PRODUCT CHANGE NOTIFICATION

#PCN-IFC-X0KC-16

Business Unit	Product Line Code	Type of Change	Action	Date of issue
IFC	BF7	Mechanical	Notify Distributors and Field	6/2/2016

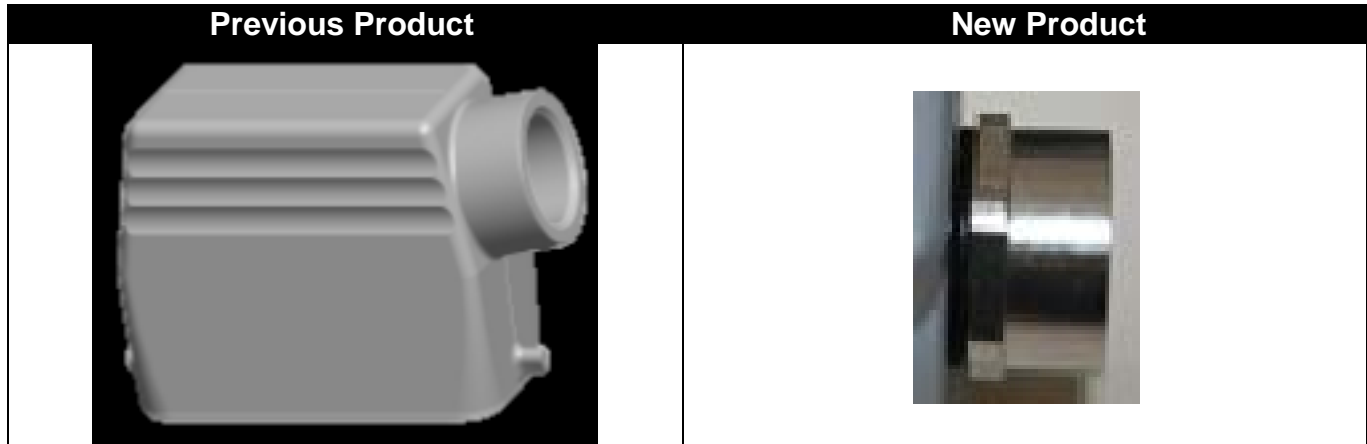
Due to manufacturing reasons, the previously cast thread support on D-series housings will be removed. In the future, this support will be accomplished using a brass support threaded into the housing.
